RENESAS TECHNICAL UPDATE

Product Category	MPU&MCU	Document No.	TN-16C-A174A/E	Rev.	1.00
Title	Errata to R32C/111 Group Hardware Manual		Information Category	Technical Notification	
Applicable Product	R32C/111 Group	Lot No.	Reference Document	R32C/111 Group Hardware Manual Rev. 1.00 (REJ09B0424-0100)

This document describes corrections to the R32C/111 Group Hardware Manual, Rev. 1.00.
The corrections indicated in red list as follows:

Figure 25.14 Program Command Flow

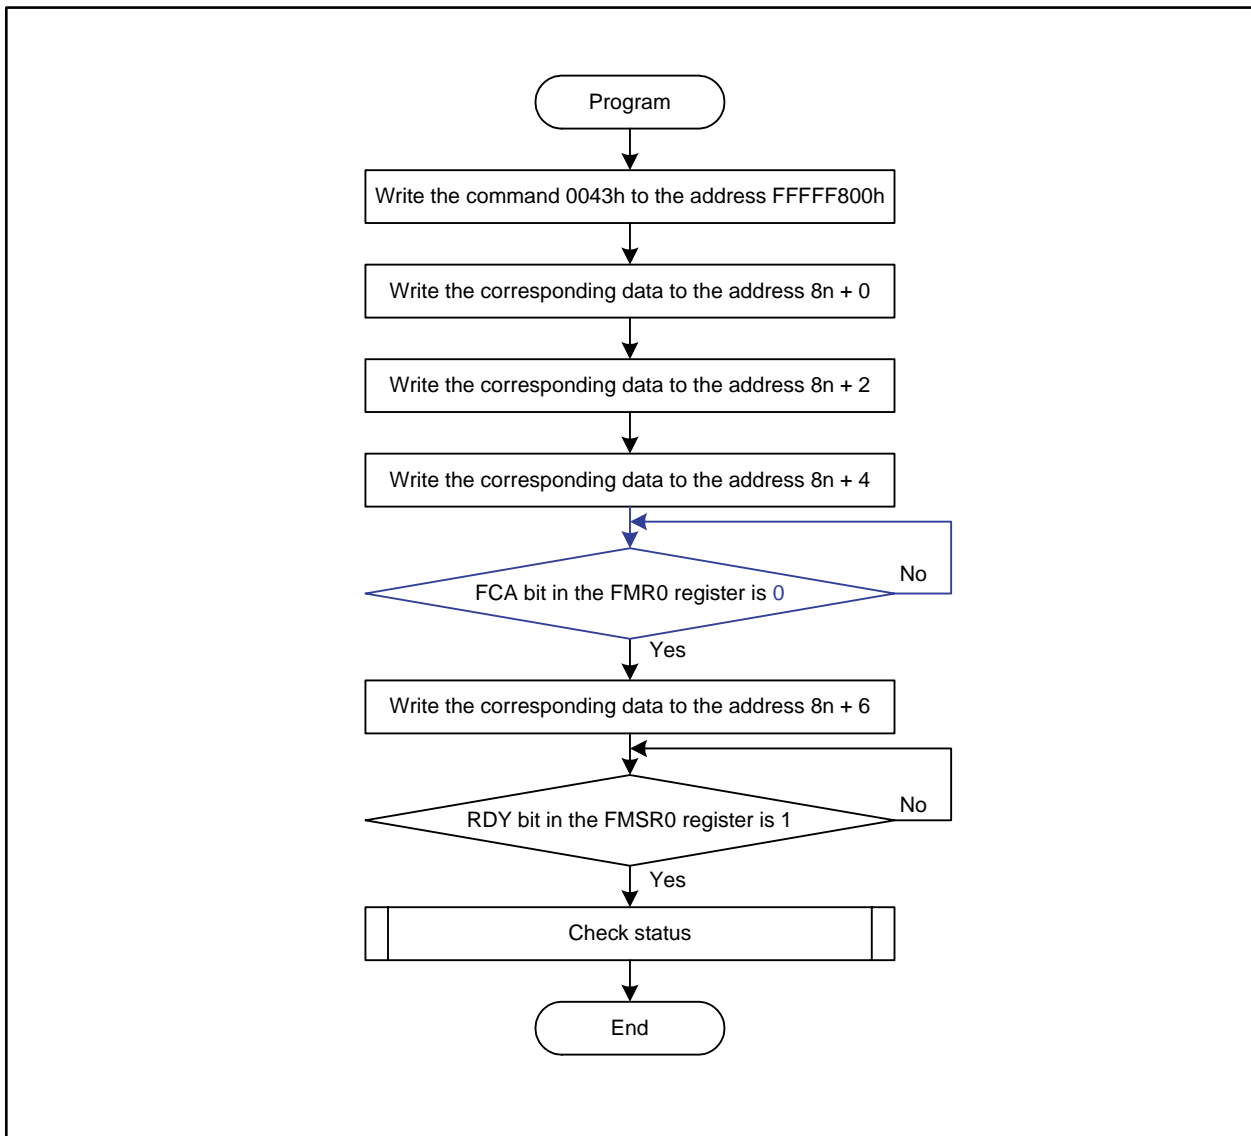
•Pages 393 to 397 of 464, flowcharts in Figures 25.14 to 25.18 are corrected as follows:
